Work Order ID 136915

Item Name: Quick Release Heli-Utility-Basket™ Long, Light Lid, Spacepod™/Squirrel Cheek Comp

DART SERVICE INSTRUCTION

TO AMEND INSTALLATION INSTRUCTIONS D350-607-3 Rev.D,
INSTALLATION INSTRUCTIONS D350-607-4 Rev. C AND
INSTRUCTIONS FOR CONTINUED AIRWORTHINESS ICA-D350-607 REV. 6

FIGURE 1: INSTALLATION OF D4775-041 FWD STRUT

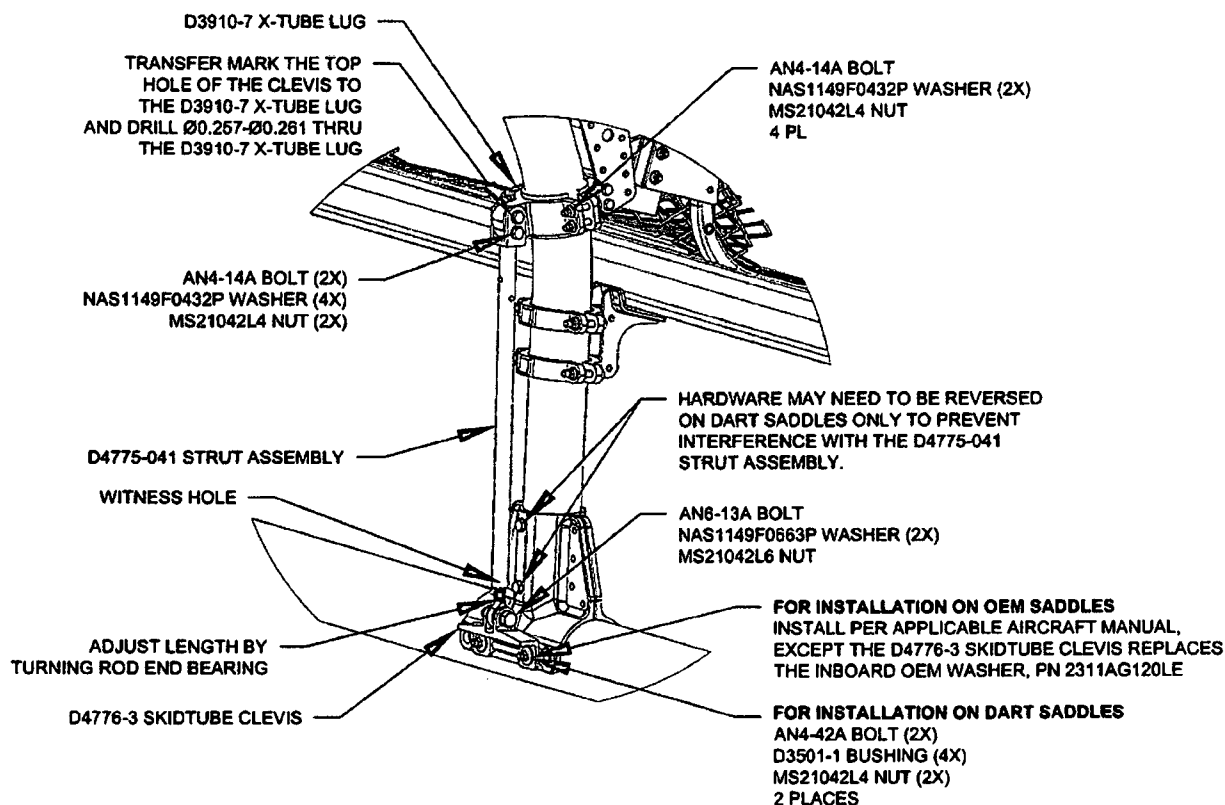
- 3.1 Substitute the Forward Lower D3910-5 X-Tube Lug with the D3910-7 X-Tube Lug as shown in Figure 1.
- 3.2 Install the forward D4775-041 Strut Assembly. Transfer mark from the upper hole on the clevis of the D4775-041 Strut Assembly to the D3910-7 X-tube Lug and drill thru the lug $\varnothing 0.257$ - $\varnothing 0.261$ as shown in Figure 1. Touch up chemical conversion coating per MIL-DTL-5541. Check the witness holes located at the bottom end of the D4775-041 Strut Assemblies to ensure that the thread from the rod end extends past the witness hole.
Torque MS21042L4/-4 nuts to 50-70 in-lbs (5.7-7.9 N-m). Torque MS21042L6/-6 nuts to 160-190 in-lbs (18.1-21.5 N-m).
- 3.3 Complete the installation in accordance with Installation Instructions D350-607-3 Rev. D or D350-607-4 Rev. C.
